# HISTORIC AND DESIGN REVIEW COMMISSION

**HDRC CASE NO:** 2023-384  
**ADDRESS:** 315 REFUGIO ST  
**LEGAL DESCRIPTION:** NCB 714 BLK 11 LOT S 67 FT OF 12  
**ZONING:** RM-4, H  
**CITY COUNCIL DIST.:** 1  
**DISTRICT:** Lavaca Historic District  
**APPLICANT:** David Hannan Jr/FISHER HECK ARCHITECTS  
**OWNER:** KNIGHT ROBERT WILLIAM & RAMON ALEJANDRO  
**TYPE OF WORK:** New construction of a 2-story addition  
**APPLICATION RECEIVED:** September 14, 2023  
**60-DAY REVIEW:** November 13, 2023  
**CASE MANAGER:** Rachel Rettaliata

1. Modify the fenestration on the primary structure.
2. Construct an approximately 764-square-foot, 2-story rear addition.

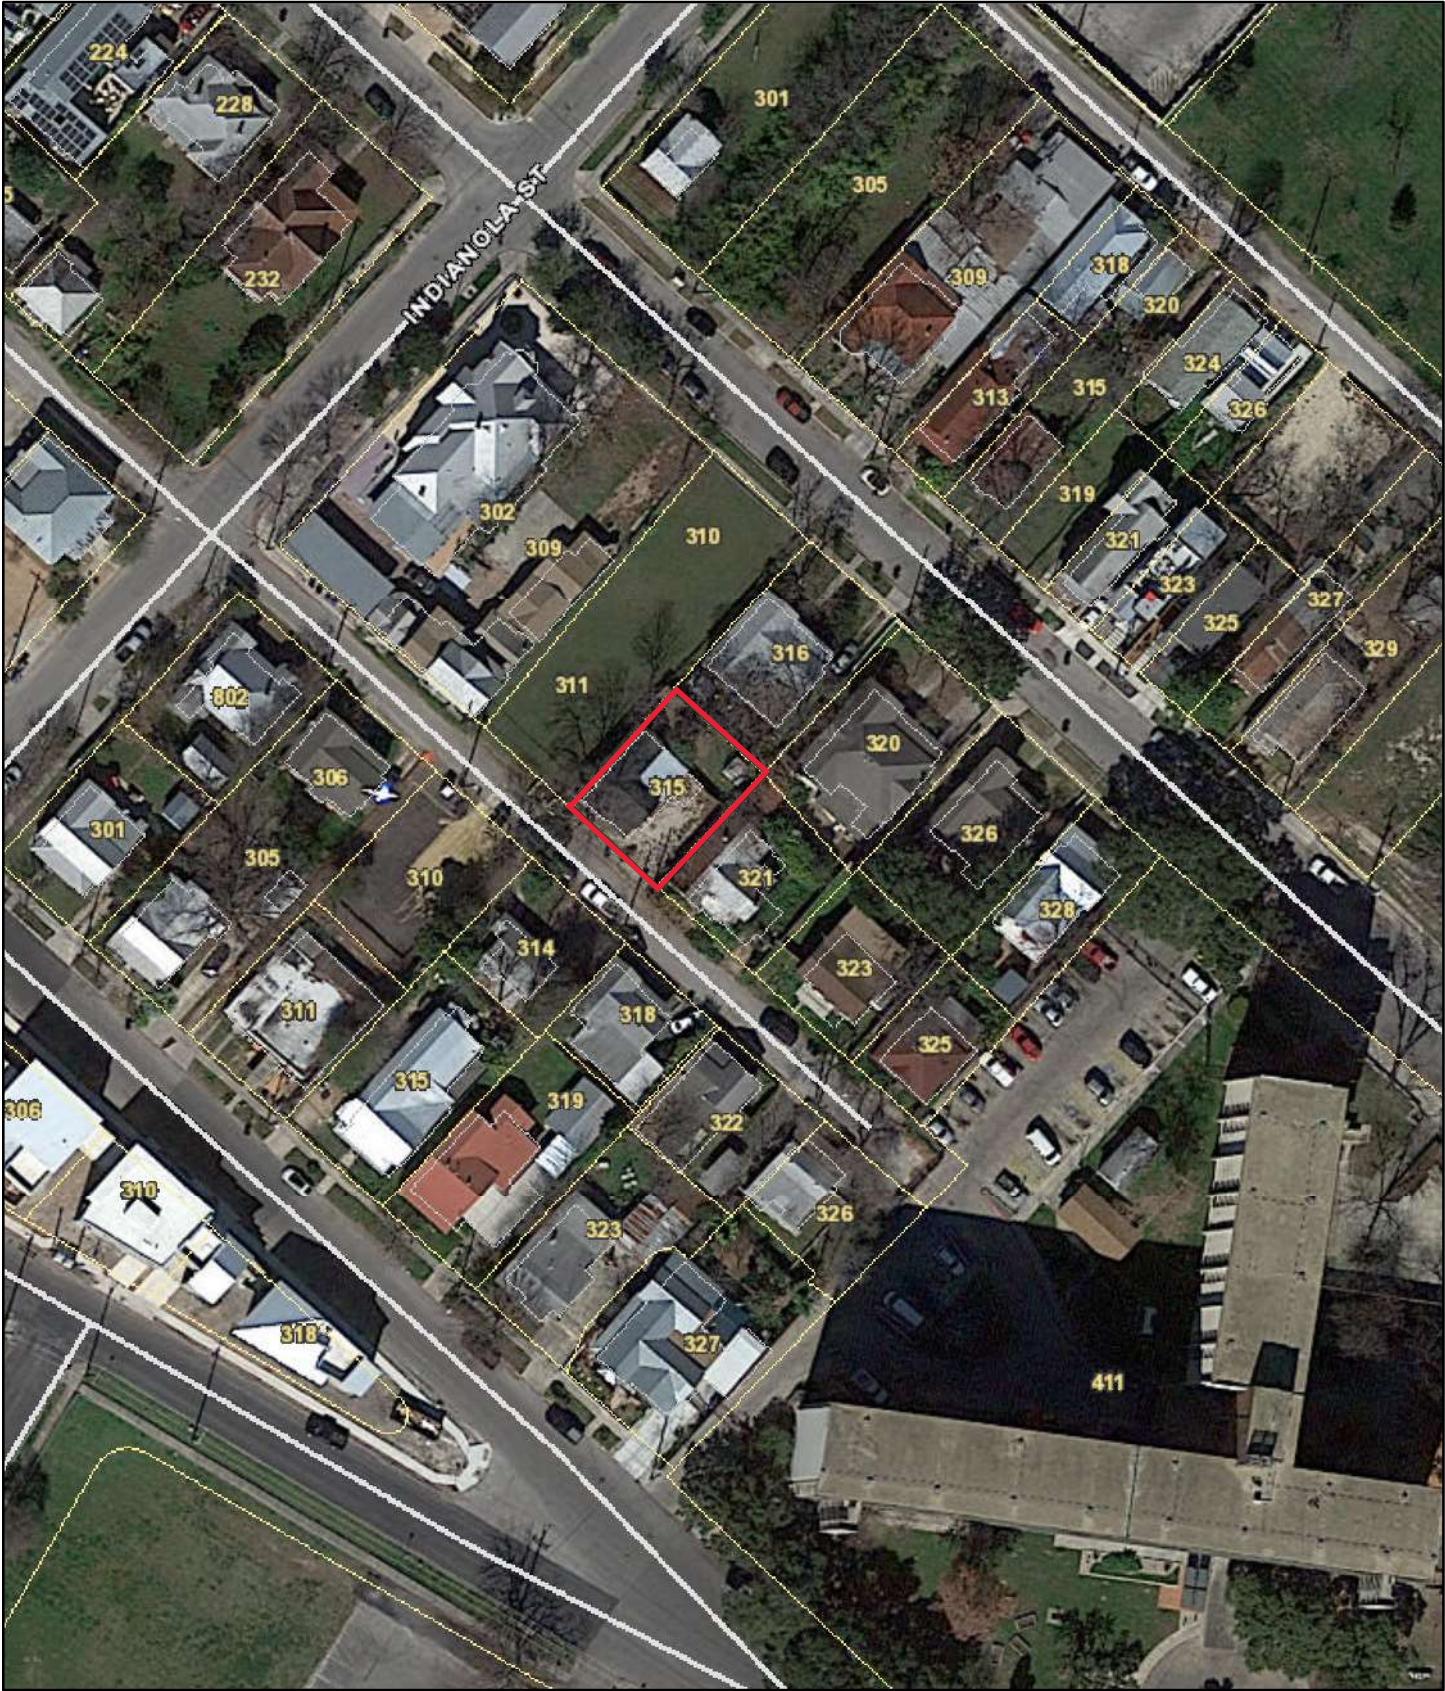
Item 1, staff recommends approval of the fenestration modification to the rear elevation based on finding d with the following stipulations:

- i. That the applicant updates the proposal to feature a door with sidelites only and that the fixed transom-like windows are not installed above the door opening. An updated elevation drawing must be submitted to staff for review and approval prior to the issuance of a Certificate of Appropriateness.
- ii. That the applicant submits final material specifications for the proposed replacement door and sidelites to staff for review and approval prior to the issuance of a Certificate of Appropriateness. A fully wood door and fully wood sidelites would be most appropriate.

EXISTING REAR FACADE

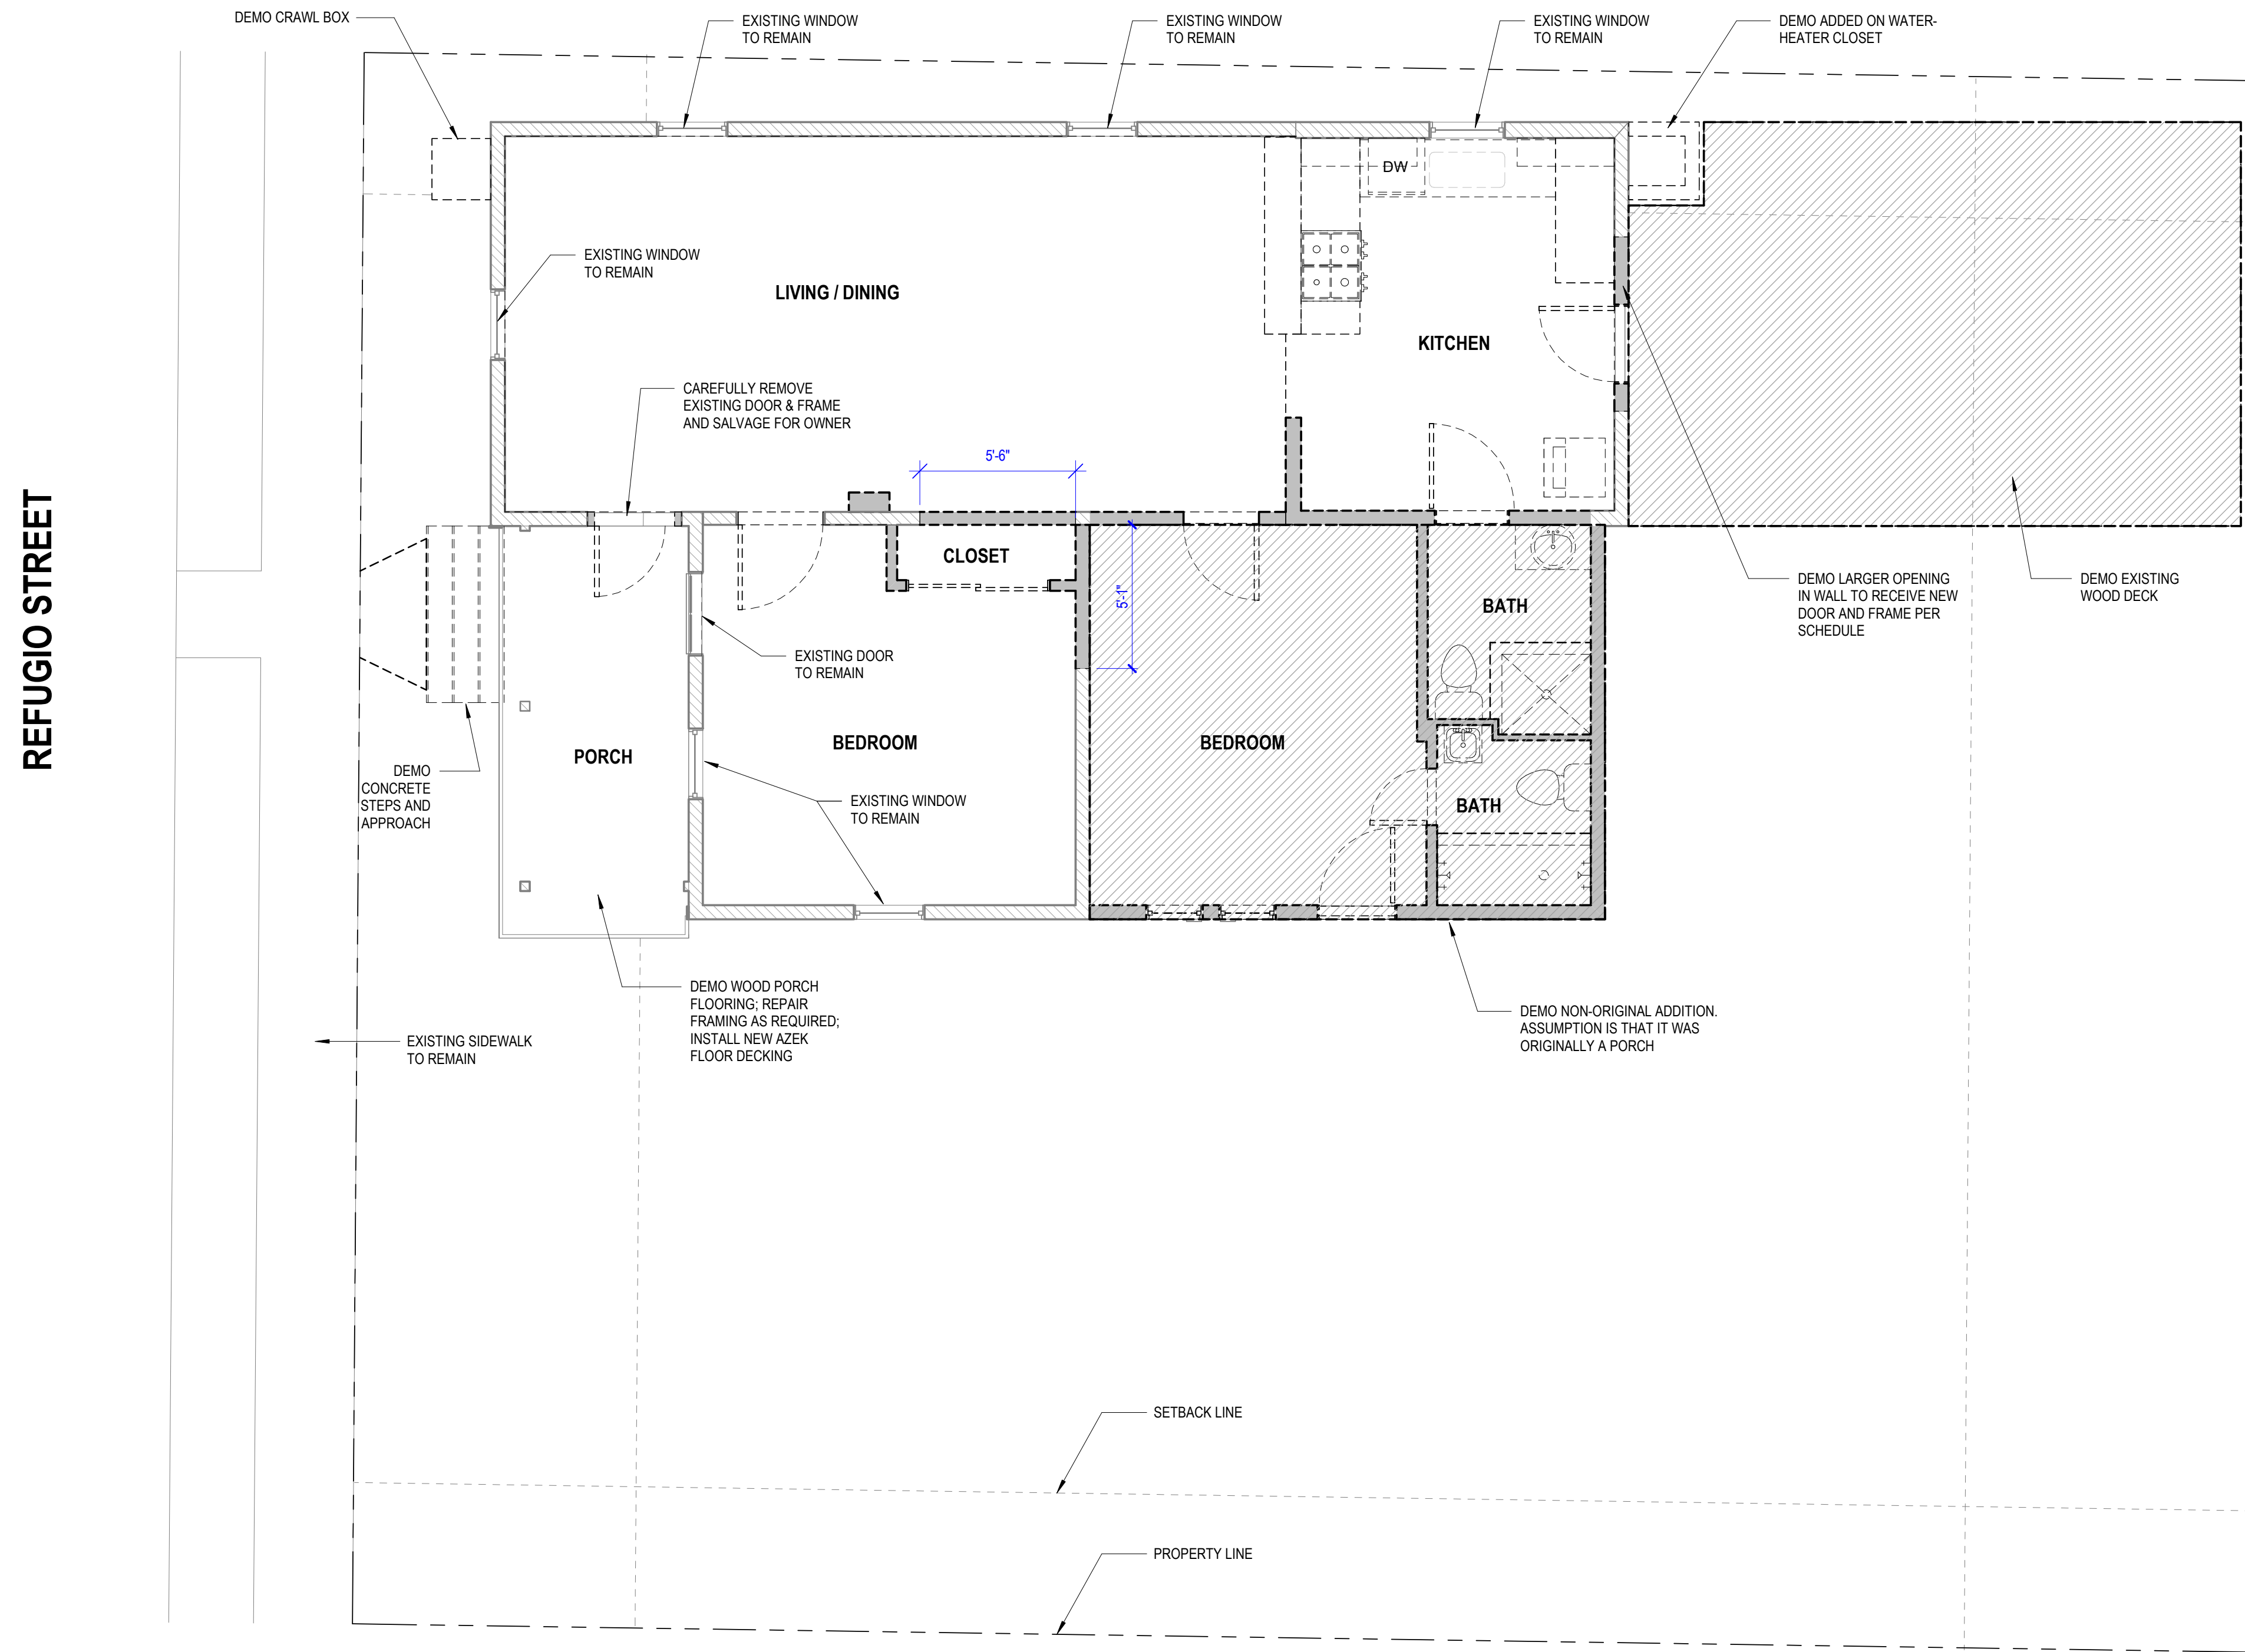
e. **REAR FENESTRATION MODIFICATION** – The applicant has proposed to remove the existing rear door to accommodate the installation of a full-lite door with sidelites. Guideline 6.a.ii for Exterior Maintenance and Alterations states that historic doors including hardware, fanlights, sidelights, pilasters, and entablatures should be preserved. Staff finds the proposal generally appropriate but finds that the applicant should submit additional evidence that the rear door is not original to the structure and final material specifications for the replacement door and sidelites for staff to review.

- I. That the applicant provides evidence to staff that the existing rear door is not original to the structure.
  - a. We've included a different photo within the existing photos sheet, HDRC-1, that illustrates the ghosting of a prior window that overlaps a section of the existing door. The window opening has since been filled in, while some of the previous trim remains in place. A rear door would most likely have been on the side of this room, which most likely would have led to a back porch. That porch has since been enclosed with a previous addition.
